Access Compliance Report Public Rights-of-Way (Curb Ramps)

Intersection ID: 14396	Main Street: BRIAR_CREEK_RD	Cross Street: COMMONWEALTH_AV	Location: S
ADA ID: D61615673843	Ramp Type: Perp	Initial Pass/Fail: Fail	Overall Compliance: No Severity Score: 26.25

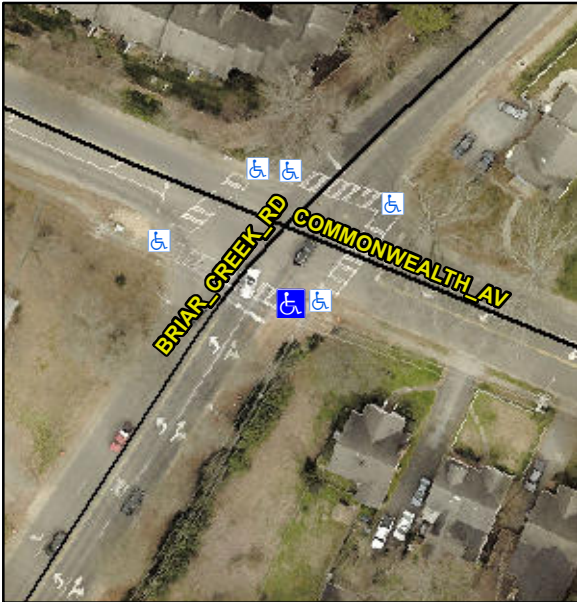
PROW/ADA:
Not Found, R304.2.2, R304.5.3

Compliance	Description	Data	Compliance	Description	Data
N/A	Ramp Length (in)	27.0	No	Ramp Slope (%)	15.6
Yes	Ramp Width (in)	48.0	No	Ramp XSlope (%)	2.6
N/A	Flare Type LT	N/A	N/A	Flare Type RT	N/A
N/A	Flare Slope LT (%)	N/A	N/A	Flare Slope RT (%)	N/A
N/A	Flare Traversable LT?	N/A	N/A	Flare Traversable RT?	N/A
N/A	Landing Length (in)	N/A	N/A	DWS Provided?	N/A
N/A	Landing Width (in)	N/A	N/A	DWS Contrast?	N/A
N/A	Landing Slope (%)	N/A	N/A	DWS Length (in)	N/A
N/A	Landing X Slope (%)	N/A	N/A	DWS Full Width?	N/A
N/A	Landing Curb? (Y/N)	N/A	N/A	DWS Offset (in)	N/A
N/A	Shared Landing?	N/A			
N/A	Gutter Ponding?	N/A	N/A	Gutter Slope (%)	N/A
N/A	Gutter Lip Ht (in)	N/A	N/A	Gutter X Slope (%)	N/A
N/A	Painted X Walk1?	Yes	N/A	Painted X Walk2?	N/A
	X Walk 1 Direction	To NW		X Walk 2 Direction	N/A
N/A	X Walk 1 Width (in)	97.0	N/A	X Walk 2 Width (in)	N/A
	X Walk 1 Slope (%)	1.1		X Walk 2 Slope (%)	N/A
	X Walk 1 X Slope (%)	1.0		X Walk 2 X Slope (%)	N/A

Possible Solutions:
Remove & Replace Entire Ramp.
